**SAN ANTONIO WATER SYSTEM
LEON CREEK WATER RECYCLING CENTER (WRC) INTERCONNECT
TO THE SOUTHWEST BEXAR SEWER PIPELINE (SBSP) PROJECT
SAWS Job No. 10-6501
Solicitation No. B-11-051-MF**

ADDENDUM NO. 3

January 25, 2012

C VENTED DROP MH #18
SCALE 1/8" = 1'-0"

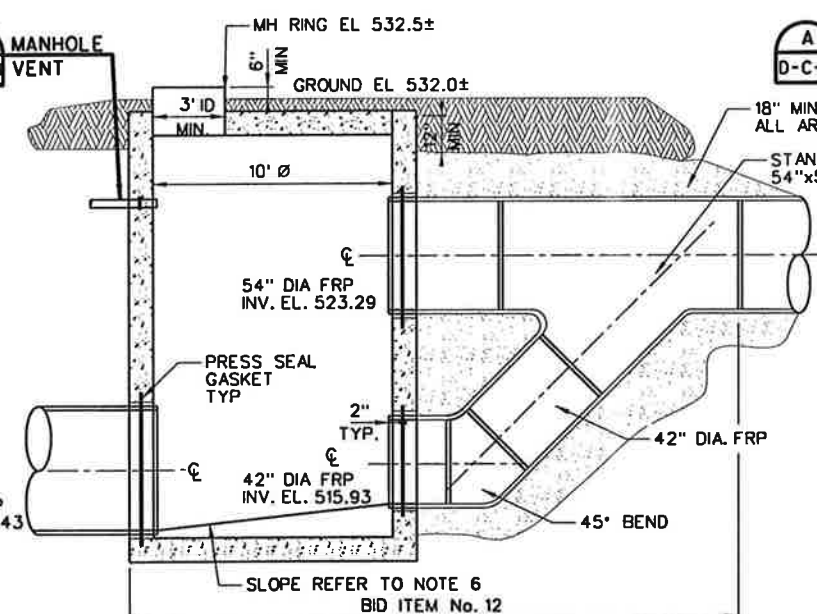
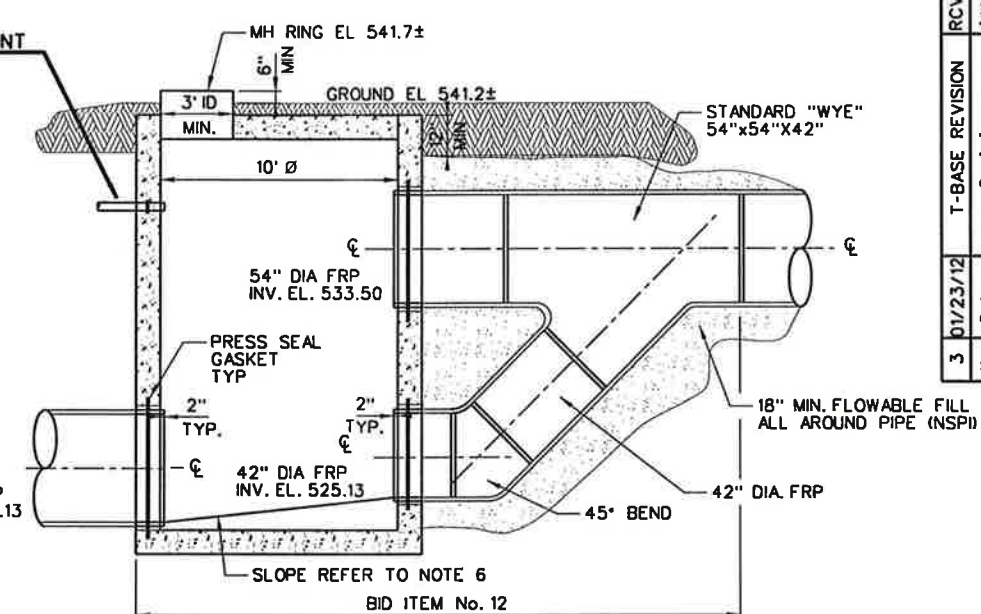
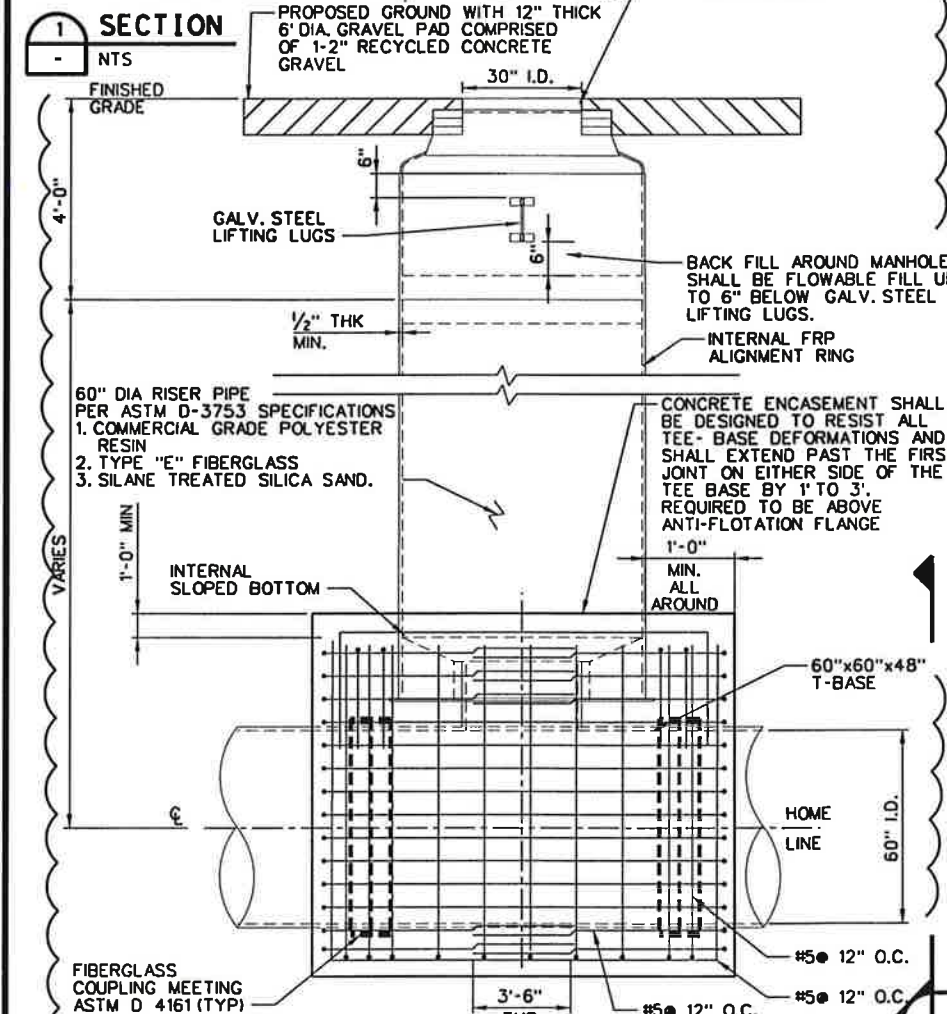
19. Question: Please confirm that the minimum concrete strength for "Vented Drop Manholes" (MH-17 & MH-18) is 9,000 psi.

Response: As stated on Sheet D-C-2, the minimum concrete strength for Vented Drop Manholes (MH-17 and MH-18) is 9,000 psi.

Delete this drawing in its entirety and replace with the attached drawing D-C-2.
12. DRAWING NO. D-C-7, add the following note to this drawing:
